LOCATION HWY 403 AT C.N.R. CROSSING
(DETENTION POND)

Re: Highway 403 Advance Structure Approaches
Highway 25 to Walkers Line
Draft Non-Standard Special Provisions (NSSP)
W.P. 410-85-00

memorandum

Re: Detention Pond at Hwy 403
Between Bronte Creek and CNR Subway
WP 410 85-00

Figure 1 - DETENTION POND DRAINAGE/SLOPE PROTECTION SCHEME

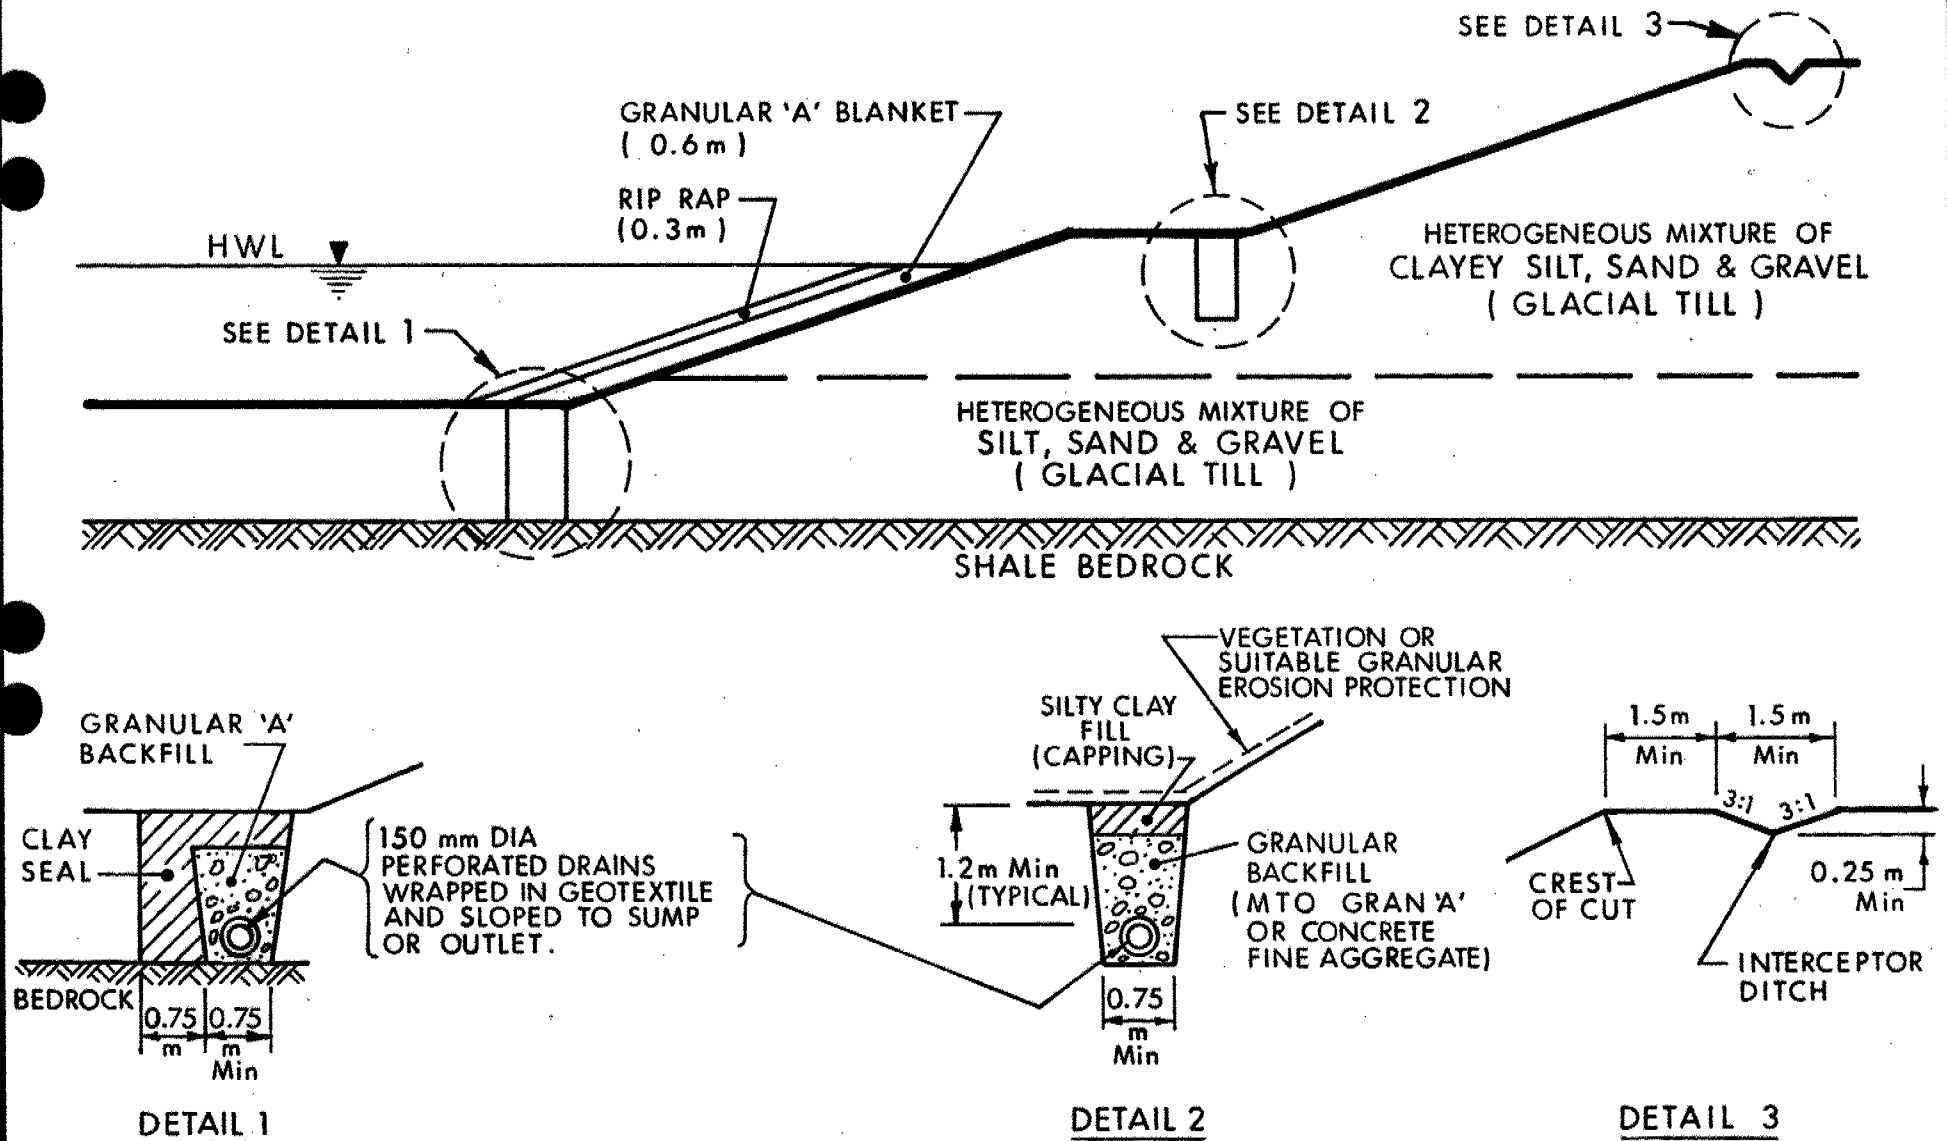
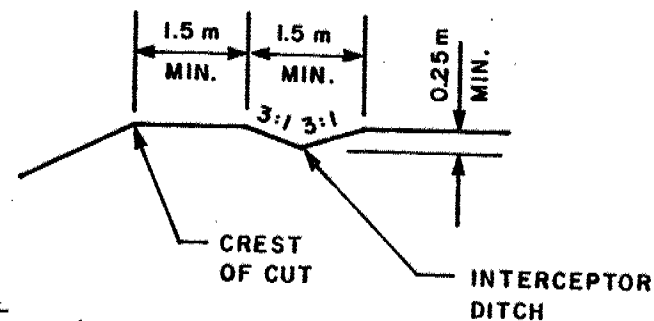
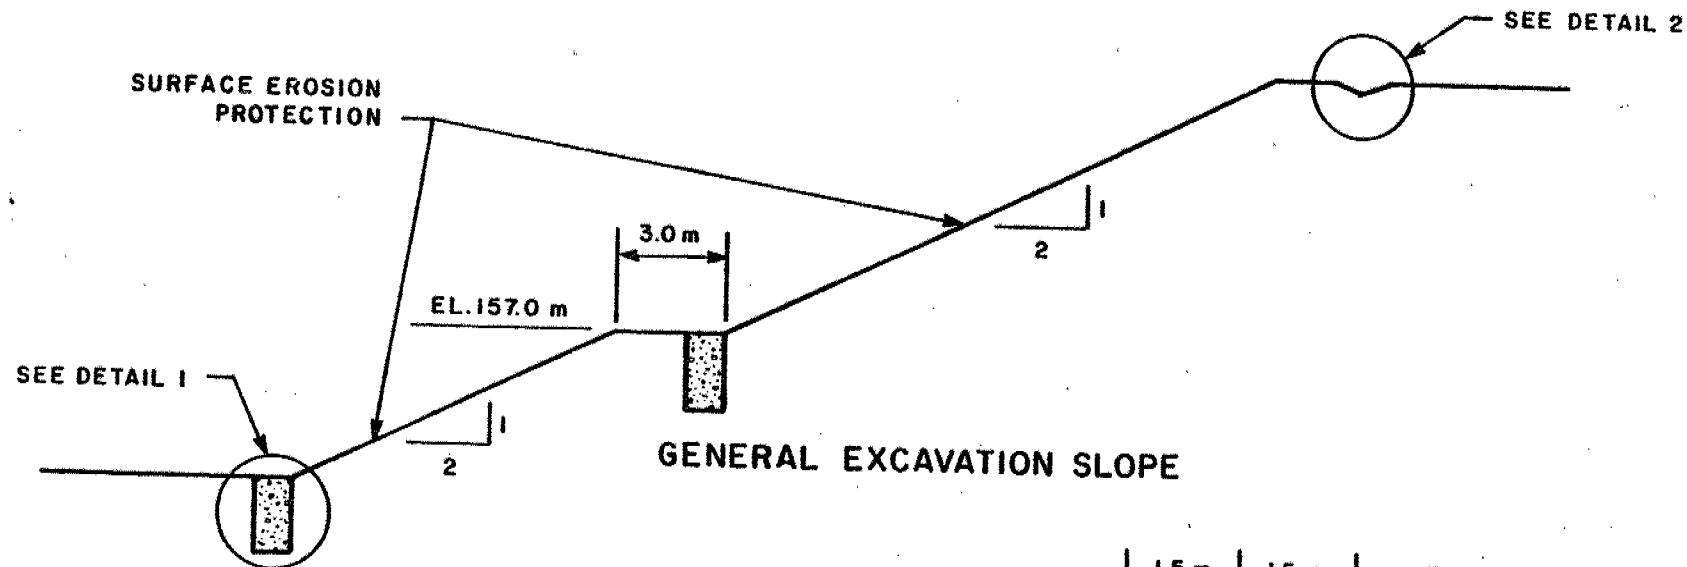
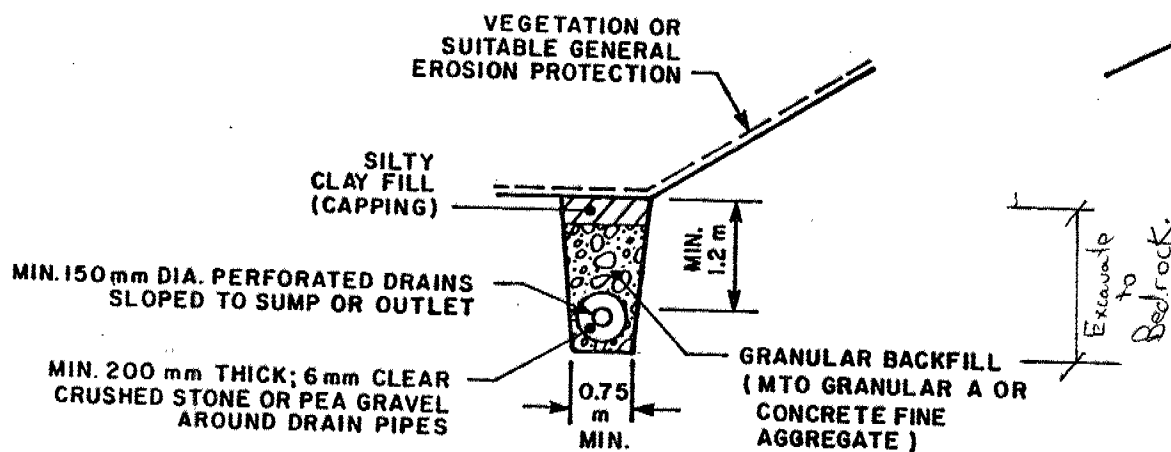
of silt, sand and gravel deposit, this seepage can be effectively controlled by employing a 0.6 m granular 'A' blanket on the slope surface of this deposit and a toe trench drain that extends for the thickness of the deposit to the bedrock surface. A trench drain is also recommended at the mid-depth bench to intercept the groundwater at the higher elevation. The trench drain-granular 'A' blanket drainage scheme will allow for groundwater drainage and simultaneously prevent slope instabilities.

The slope protection scheme shall also include rip rap or rock protection to the anticipated impounded pond high water level with the granular 'A' filter blanket between the native soil and the outer rock shell as described on page 12 of the Foundation Report (WP 410-85-00A). The granular 'A' blanket shall extend to the high pond water level or upper limit of the cohesionless heterogeneous mixture of silt, sand and gravel, whichever is greater.

Details of the recommended drainage scheme are provided on Figure 1 attached. The drainage scheme is applicable to all four(4) sides of the detention pond.

(b) It is recommended that any pond water be prevented from egressing into the groundwater drainage system. This can be achieved by constructing an impervious seal as illustrated in detail 1 in Figure 1. The impervious seal shall consist of a clay seal as defined in OPSS 1205 series.

FIGURE 6
WP 146-74-00-3

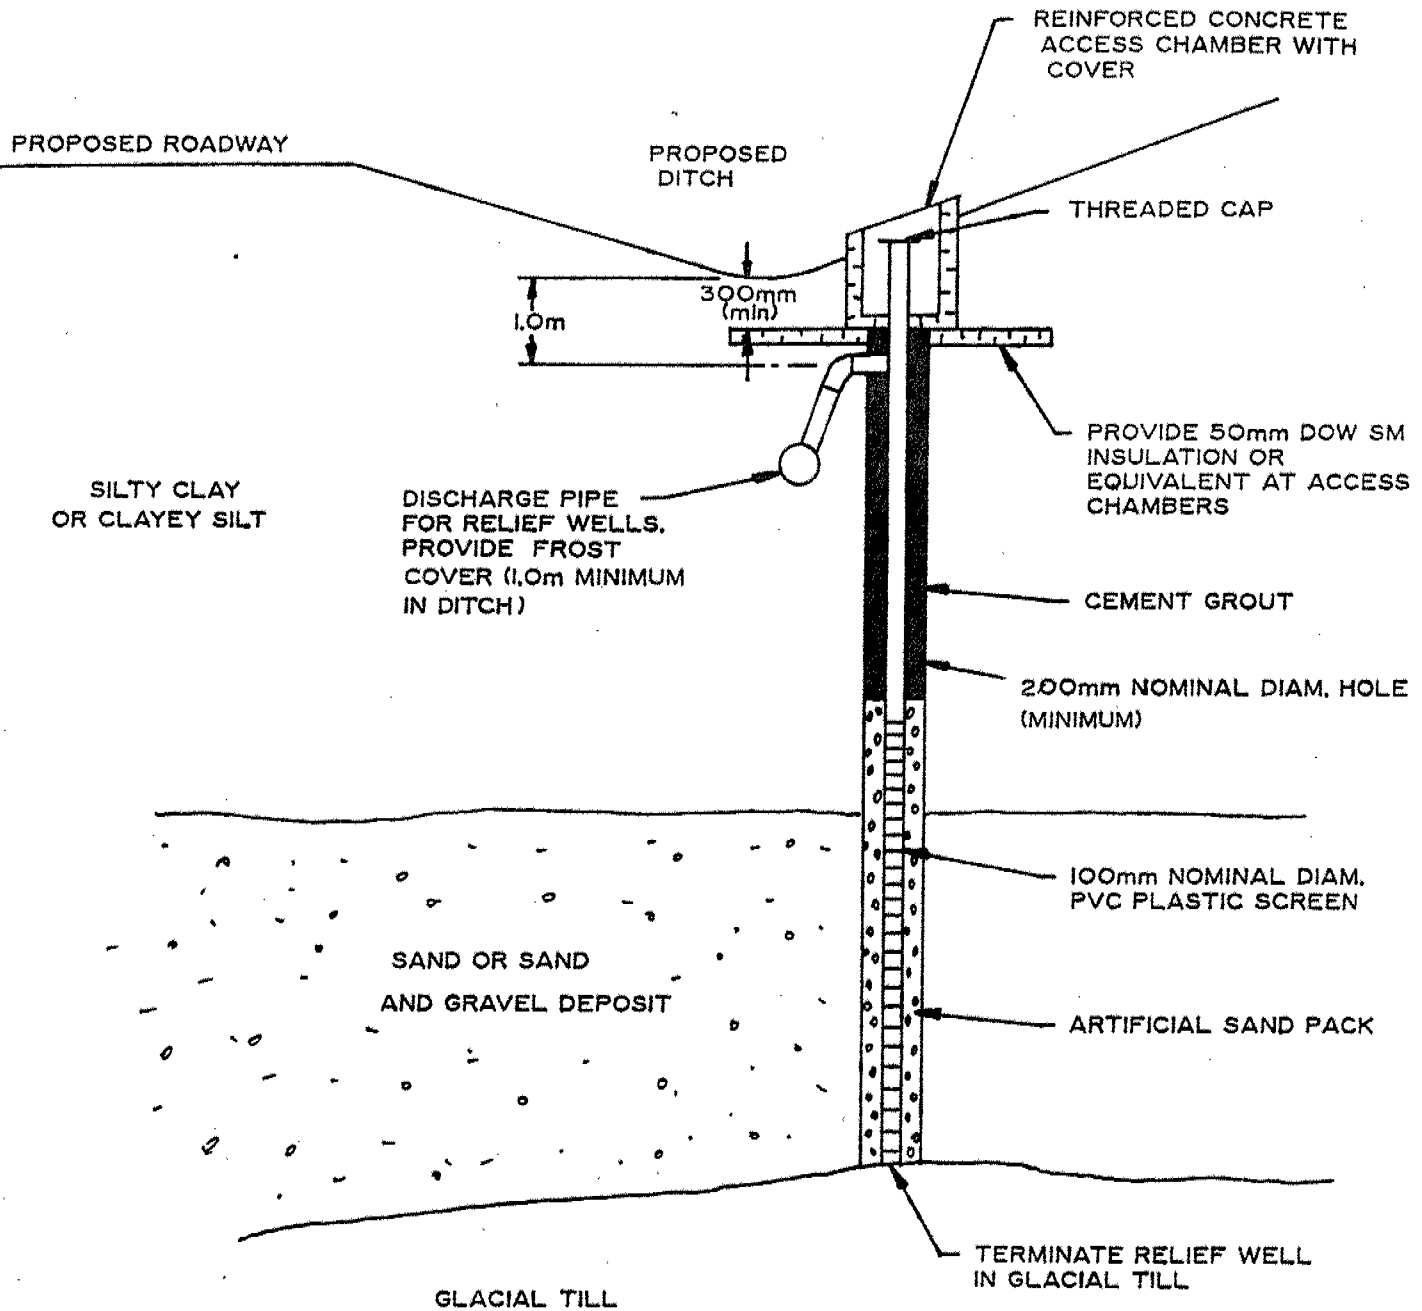
Relief wells should consist of a minimum 100 mm diameter, PVC plastic screen extending for the **FULL** depth through the cohesionless till deposit. A typical generic pressure relief well is shown on Figure 6 in the Appendix (taken from WP 146-74-00-3). The relief well system must be connected to a permanent discharge system.

The relief wells can be installed in augured holes using conventional drilling equipment. Temporary casing may be needed to prevent soil sloughing from the shaft of the hole and enable the PVC plastic screen installation.
